*IEEE 802.3cg*  
10BASE-T1S jabber problem  
*August 15<sup>th</sup>, 2018*

# Proposed solution

Figure 147-4—PCS Transmit state diagram (1 of 2)

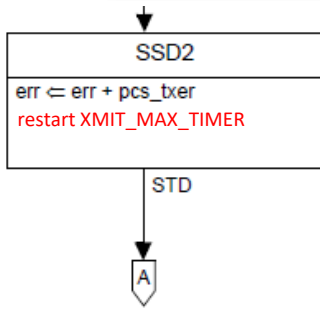
- Add XMIT\_MAX\_TIMER (2 ms ± 100 μs) to exit DATA state and notify the error to the receiving nodes
- Stay in UNJAB\_WAIT state for 16 ms ± 100 μs (or forever) to allow other PHYs to transmit
- NOTE: local CRS is high (transmitting variable is still TRUE) during unjab time to prevent the MAC from transmitting as well
- Adapted from Fig. 10-3

- In 10BASE-2 the XMIT\_MAX\_TIMER is specified to be in the range of 20 ms to 150 ms, while the UNJAB\_TIMER is specified to be 0.5 s.
- Although these numbers were fine for 10BASE-2 use cases, they might be too long for industrial and automotive requirements.
  - propose to have a XMIT\_MAX\_TIMER of  $2 \text{ ms} \pm 100 \mu\text{s}$ 
    - MAX Ethernet packet size = 1522 bytes (excluding preamble, including FCS)
    - 1522 bytes @10 Mbit/s = 1.2176 ms  $\rightarrow$  2 ms is already an oversized value
  - propose to have an UNJAB\_TIMER of  $16 \text{ ms} \pm 100 \mu\text{s}$ 
    - allows faster recovery from temporary errors at the expense of more traffic disruption in case of permanent (unrecoverable) error
- Feedback would be appreciated

- Adopt changes to Figures 147-4/1 and 147-5 as in slide #3
- 147.3.2.6 Timers
  - XMIT\_MAX\_TIMER
    - Defines the maximum time the PCS Transmit state machine can stay in DATA state.  
The XMIT\_MAX\_TIMER shall be implemented in such a way that, upon expiration, an even number of nibbles has been sent to prevent the MAC from counting false alignment errors.  
Duration:  $2\text{ms} \pm 100 \mu\text{s}$
  - UNJAB\_TIMER
    - Optionally times the minimum duration the PHY suppresses any transmission before reverting to normal operations.  
Duration:  $16\text{ms} \pm 100 \mu\text{s}$
